APPENDIX B ARCHITECTURAL DESIGN REPORT

BUILDING J DESIGN REPORT SSD Application

Museums Discovery Centre

APPENDIX D: SDRP RESPONSE

PUBLIC DOMAIN

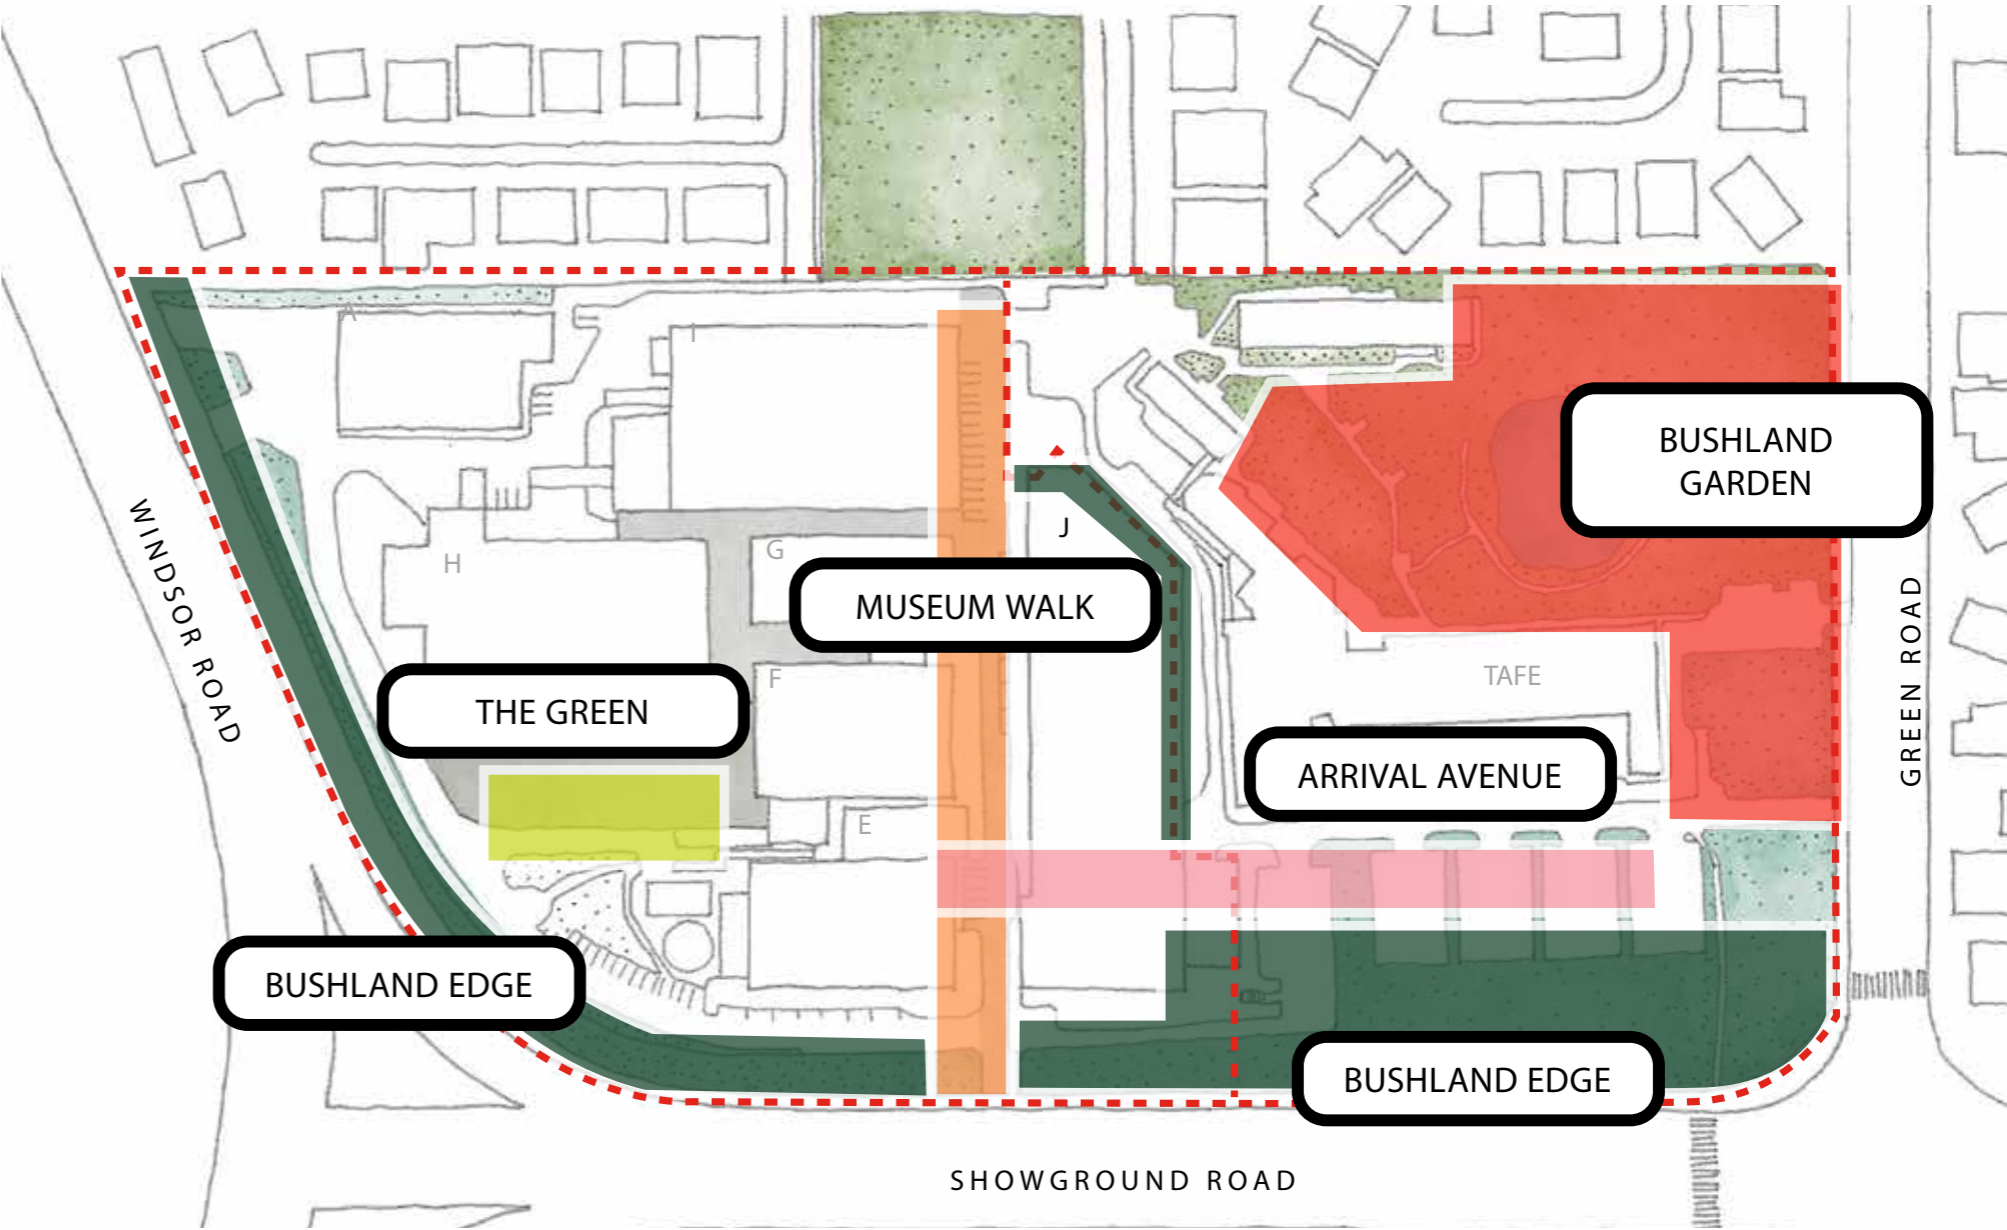
The success of the project hinges on the creation of a public domain framework to civilise the site and create the interface between the building and areas beyond, including the greater site, TAFE and broader urban context. Greater emphasis on the creation of the public domain and its integration with the building is required to support this. Currently the typical suburban/industrial typology of a building surrounded by indeterminate space has not yet been successfully addressed.

The site area of the proposal is 6,552 square metres of which 4,424 square metres contains the building footprint of the proposed Building J. At 2128 square metres, the public domain component of the proposal is limited.

Whilst the public domain component of the project is limited, consideration has been given to long term aspirations for the entire Museums Discovery Centre (MDC). The Museum of Applied Arts and Sciences has developed master plan principles for the future development of the MDC is and when funds become available. These principles are outlined in the diagrams included in this appendix.

The design of Building J and the associated landscape conforms to these principles and establishes a framework through the design upon which future developments within MDC can build upon.

The landscape design within the proposal has been informed by both the MDC master plan principles as well as detailed review of the site's context and surrounding public domain, landscape and development. Aspect Studios utilised the master plan principles to develop character areas for the public domain within both the proposal and broader MDC site.

These character areas are outlined in the diagram on this page which demonstrates that the landscape design for the proposal is considerate of the context and maximises the utility of these areas in terms of both aesthetics and usable additions to the broader public domain. The diagram is not dependent on further expansion of the MDC site into TAFE, but responds to the existing TAFE site conditions.

FUTURE VISION

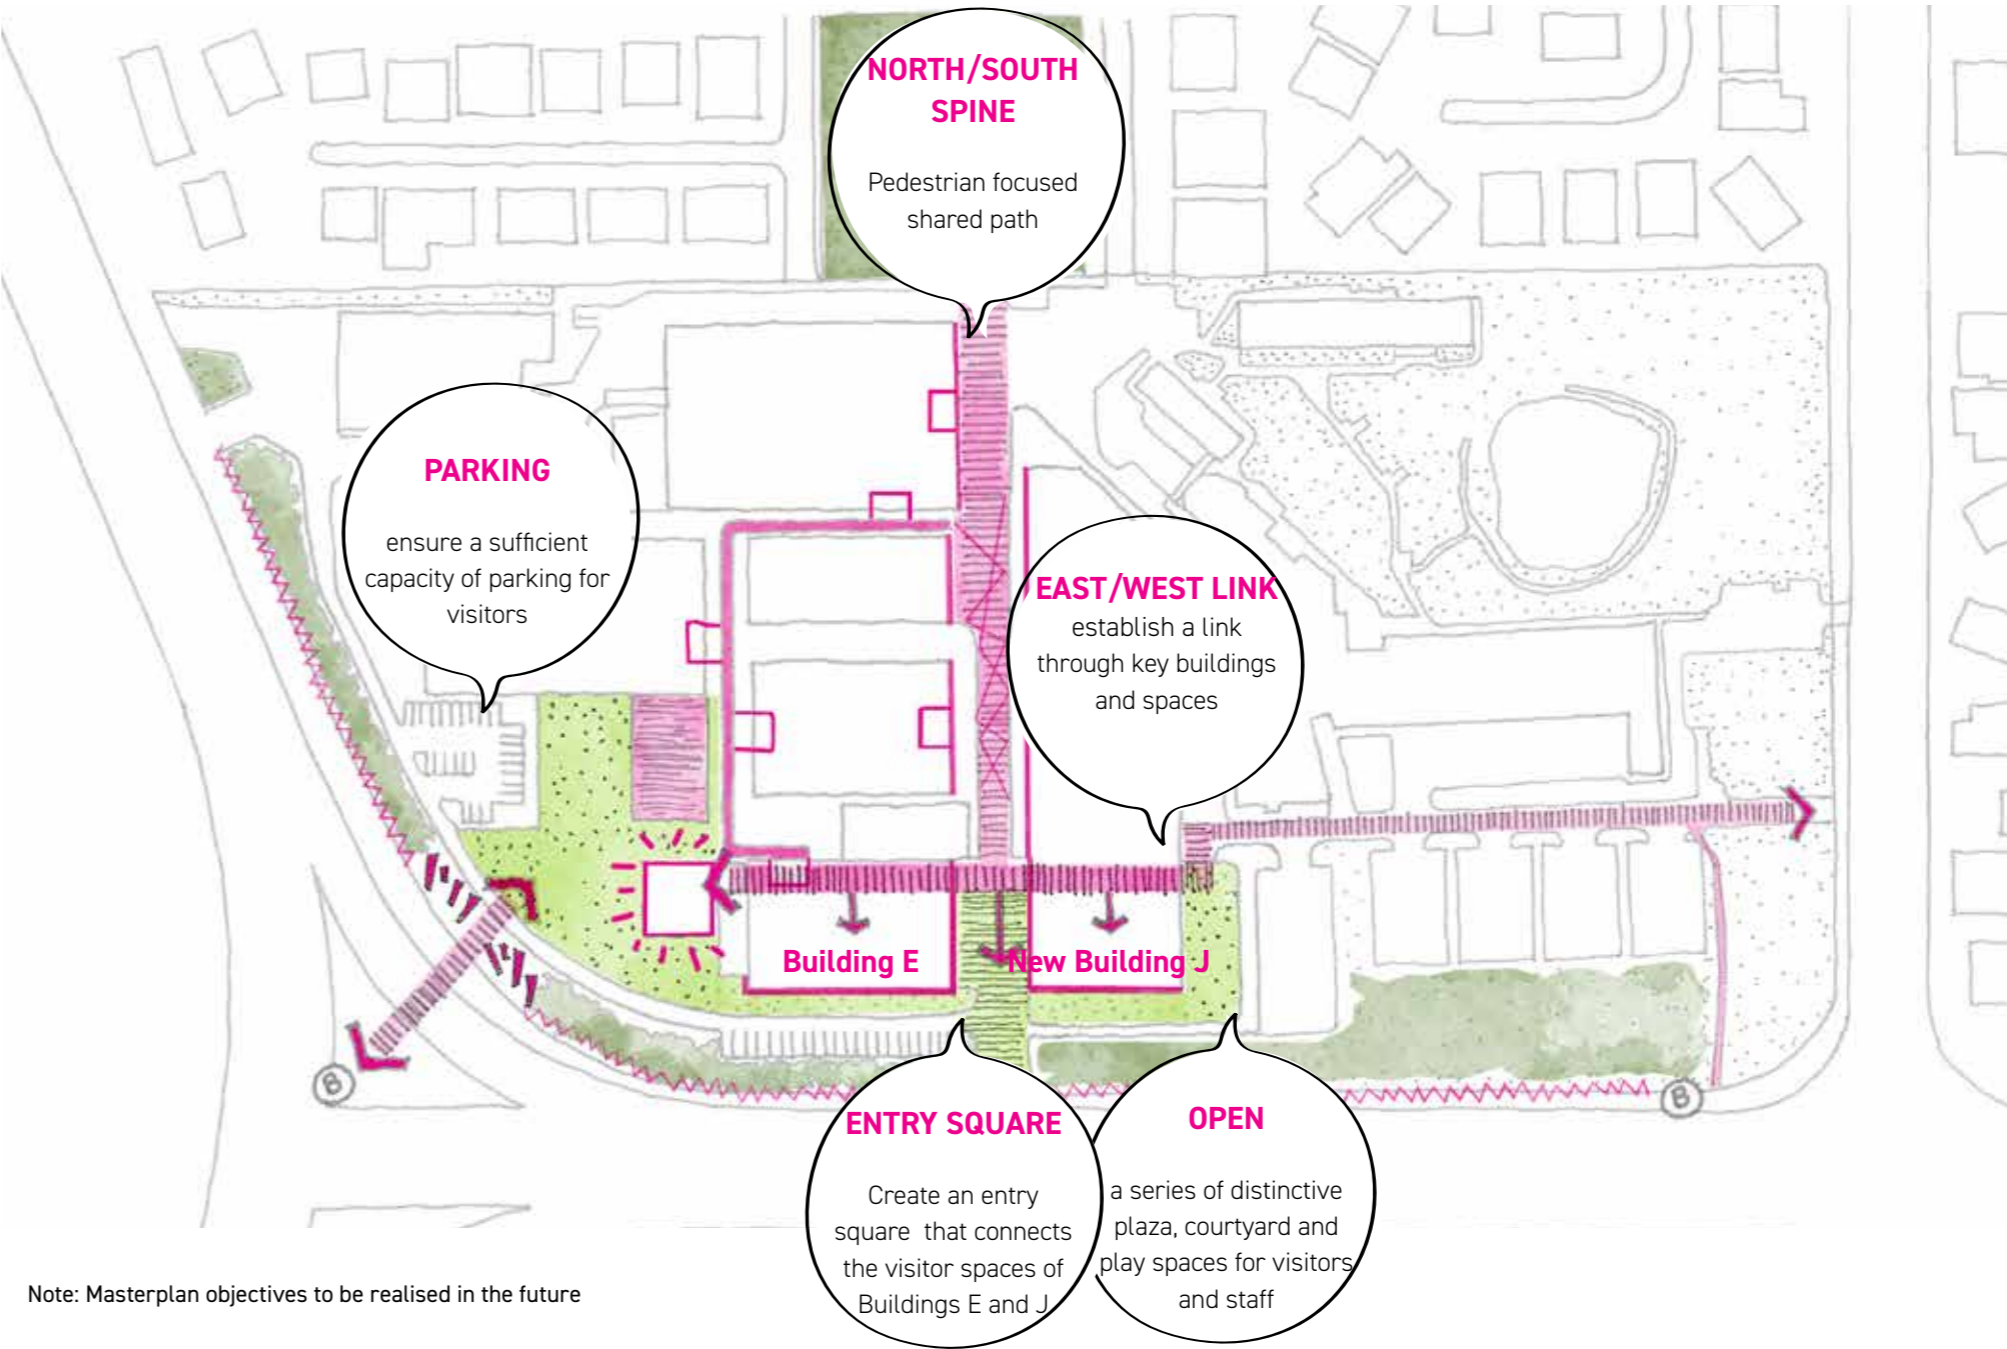
Provide a masterplan diagram that illustrates the future vision for the entire campus and details how the current plan facilitates this future vision.

The master plan principles developed by the Museum of Applied Arts and Sciences are contained within the diagram on this page. These principles outline a long term vision for the MDC site and rely on a number of built and landscape upgrades or redevelopments. The principles include:

Strengthening a North South spine through the site- this spine currently operates as a predominately vehicular connection through the site. The vision is to create a more pedestrian focused environment that can also function as a vehicular roadway as and when needed. The proposed Building J relates to this future intention through the incorporation of a landscaped swale and street trees along the north south spine. This will assist in establishing the future design of this spine which could include changes to pavement surfaces and reinvigoration of store entries on the western side of the spine.

Creation of an east-west link- this link will create a primary connection through the site within the public facing components of the MDC site. Building J has been designed to incorporate this link within the architecture. Further the landscape treatment at the eastern edge of Building J works to create a clear delineation of not only the building entry but also the commencement of this link at the Eastern extent of the site. Future works would be required to Building E to continue this link to the western edge of the site. These works would involve a reorientation of the entry to Building E off the north-south spine in line with Building J.

Further works- additional works proposed under the master plan principles include re-orienting car parking and landscape improvements to further enhance the public nature and pedestrian environment of the site.

PROJECT VISION

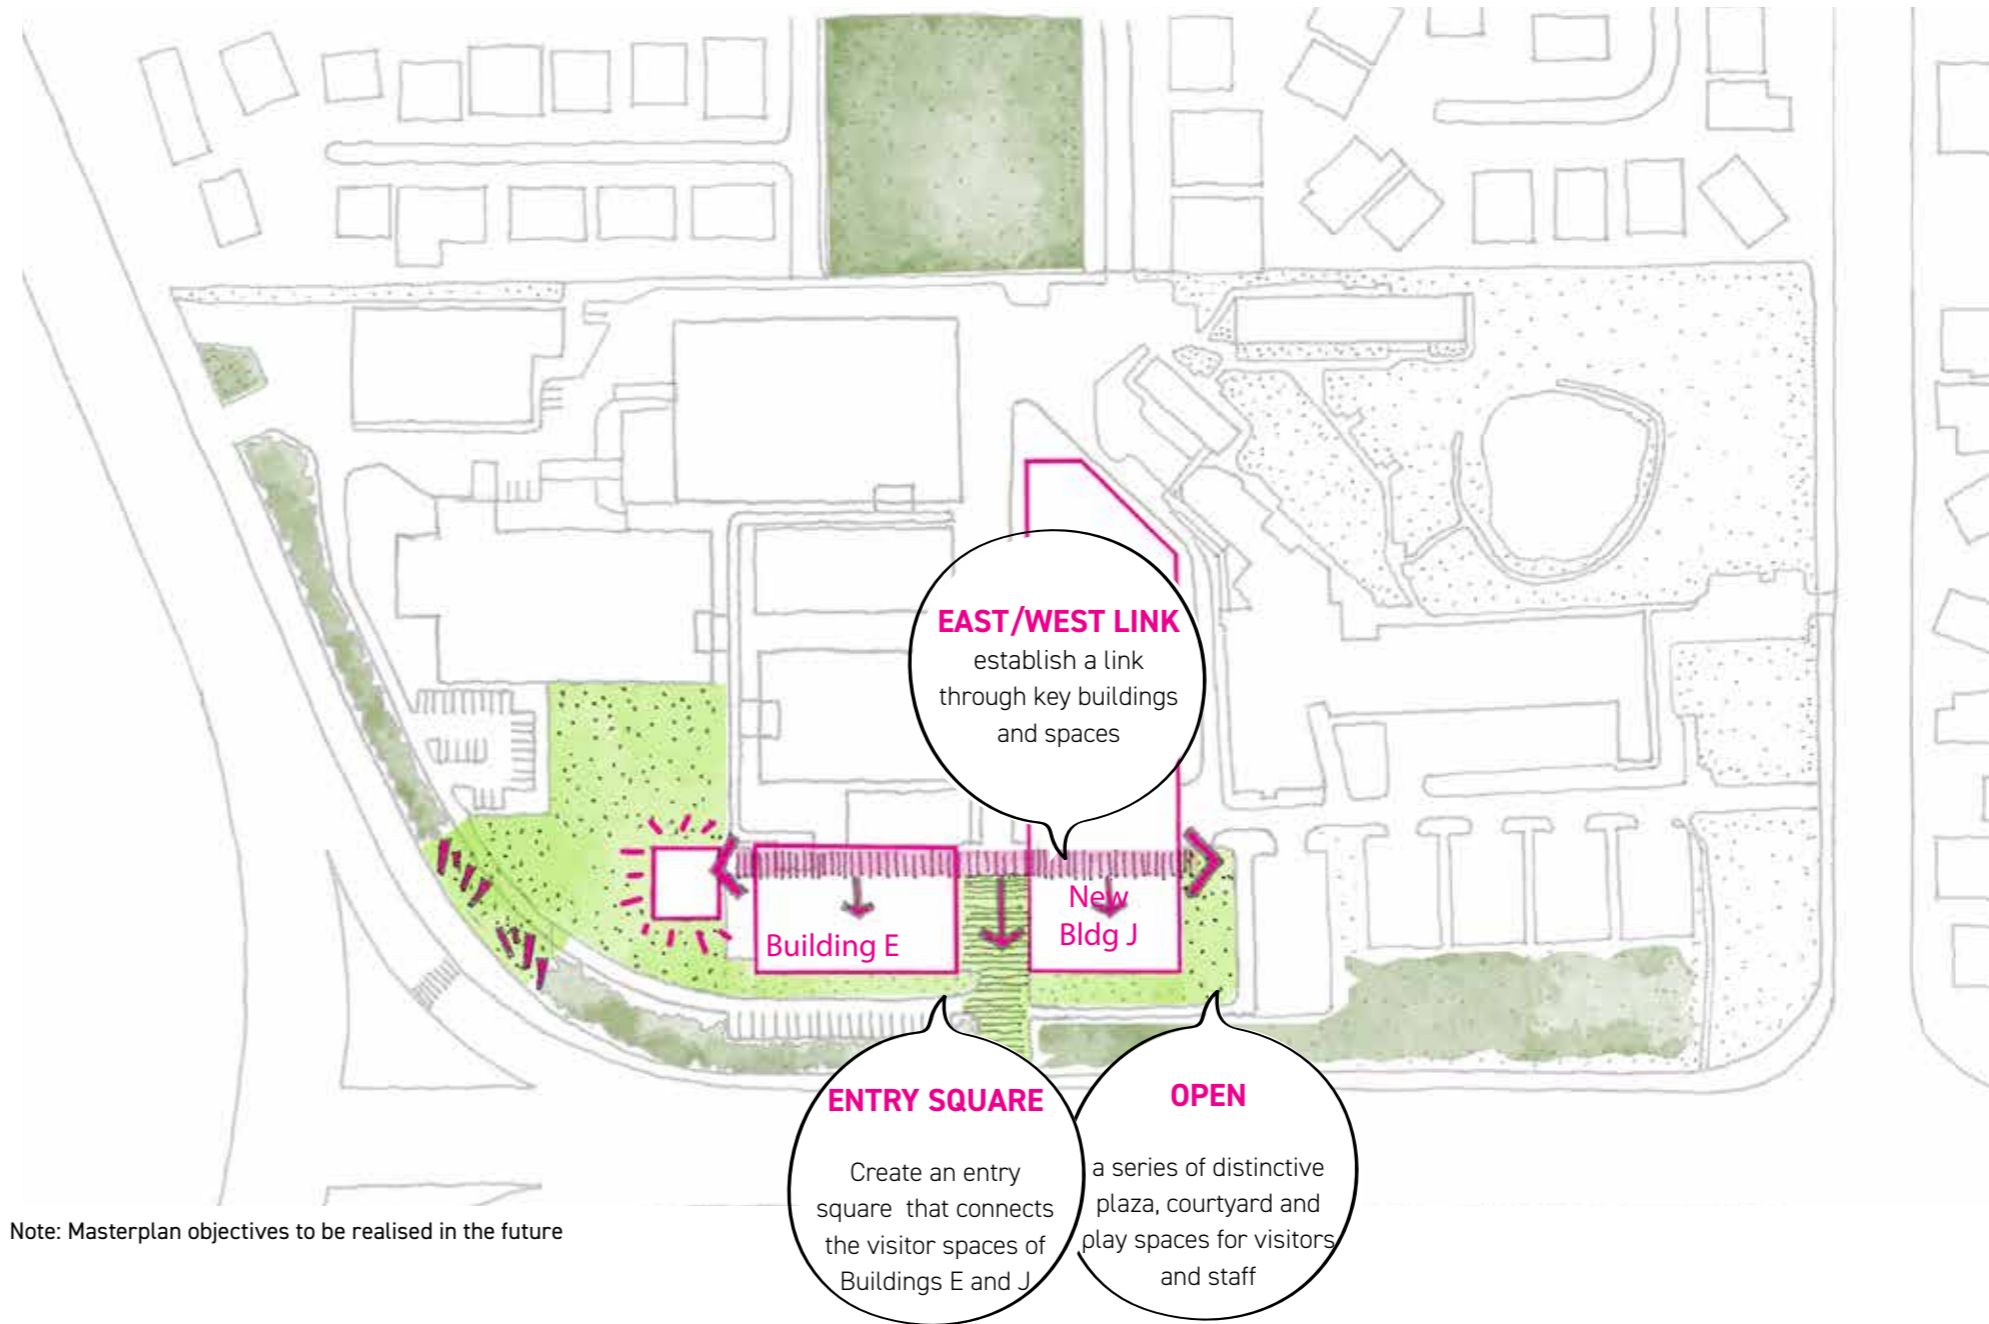
The North-South and East-West axis are key elements of the masterplan that require further development. The N/S axis should be treated as part of the public domain (consistent with the future vision for the campus) with the potential for large scale artworks to be integrated into the ground plane.

The previous page includes the long term master plan principles which includes the North/South and East/West connections through the site.

The long term design for the North/South link is outside the scope of the proposal and will be pursued by the Museum of Applied Arts and Sciences. If and when funding becomes available for these works, concepts to be explored would include:

- Pavement treatments along the north south spine to create a more pedestrian friendly environment;
- Redevelopment of store entries along the western side of the north south link to better enable connections for tours and public access to stores;
- Reorientation of parking to enable the utility when required but also other temporary community uses when not required; and
- Incorporation of art and/or interpretation that relates to the vast collection of the Museum which exists on the site.

This project will focus on the masterplan principles within the immediate area of the Building J site, being:

- Establishing an East-West through link through Building J
- Defining the entry square
